Amendments to the Drawings:

FIG. 1

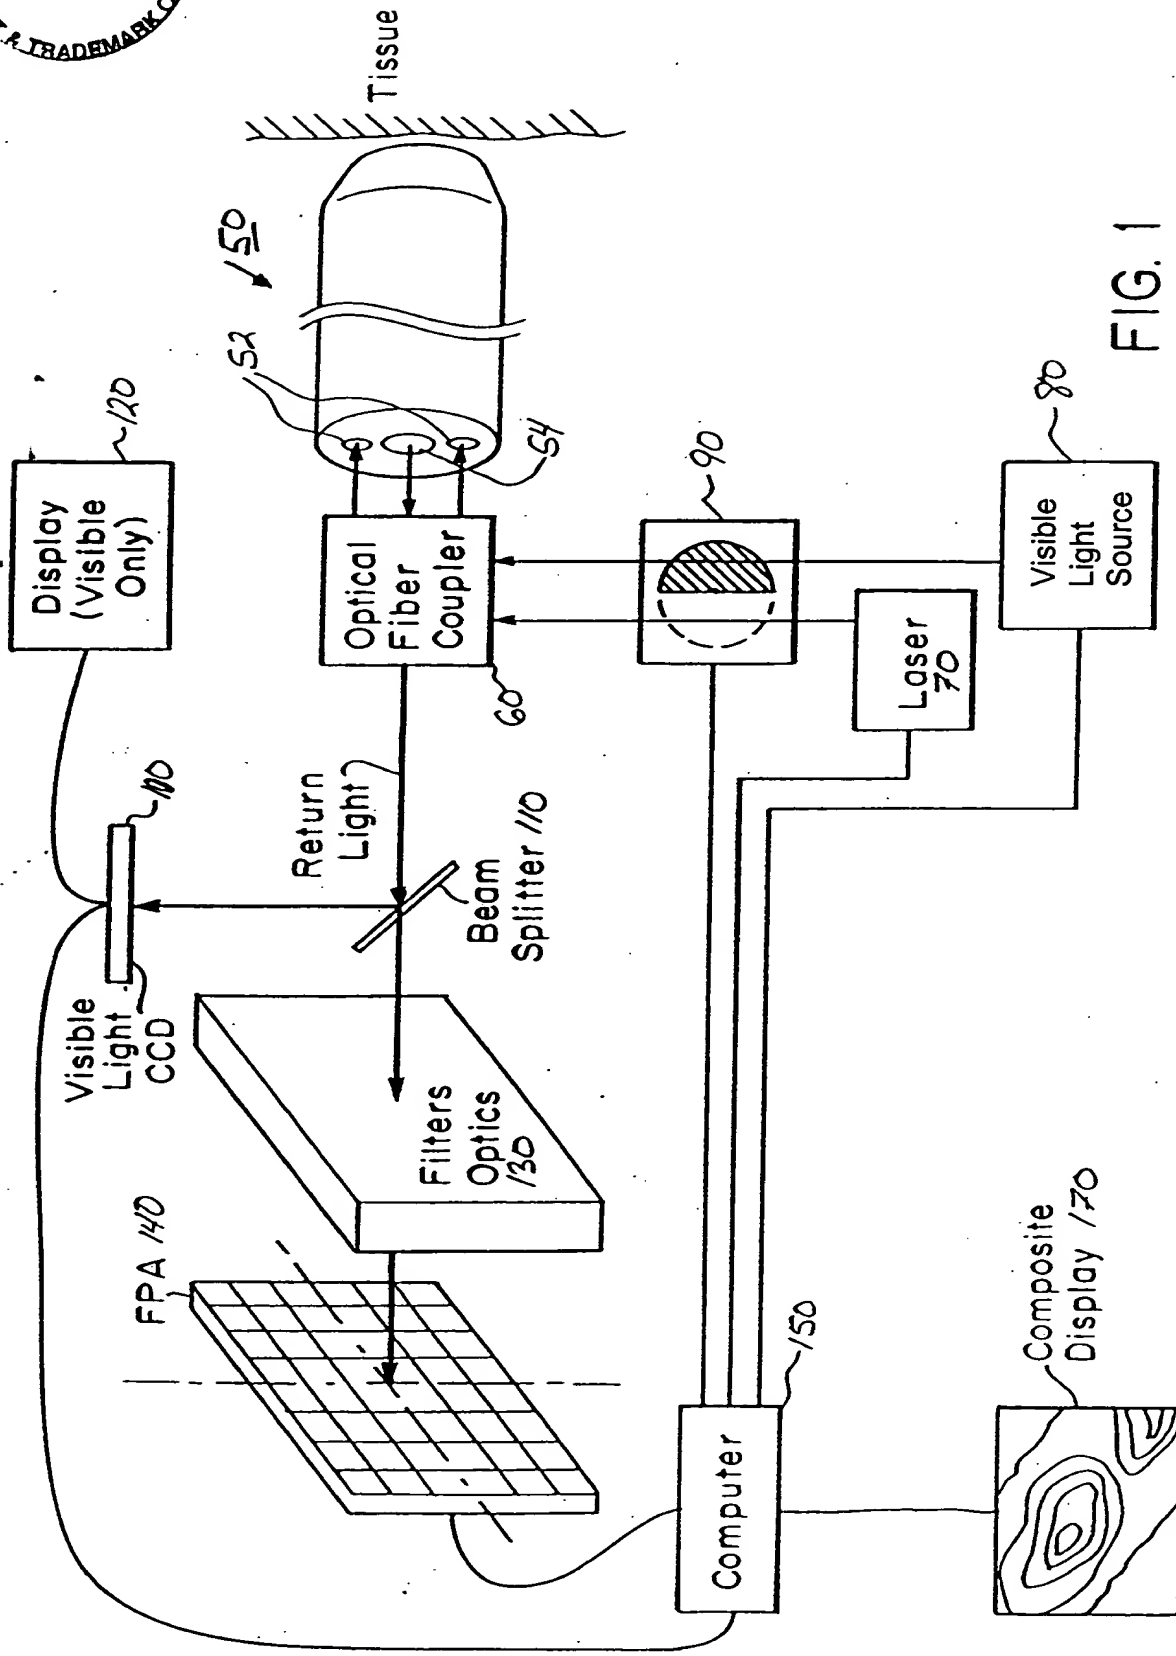
The drawing is being objected to because in figure 1, box 80 should be labeled visible light source.

Fig. 1 is being amended. The drawing objection has been obviated by the correction to box 80 by labeling it to be visible light source. Amendment to Fig. 1 is indicated on the attached Annotated Sheet of drawing.
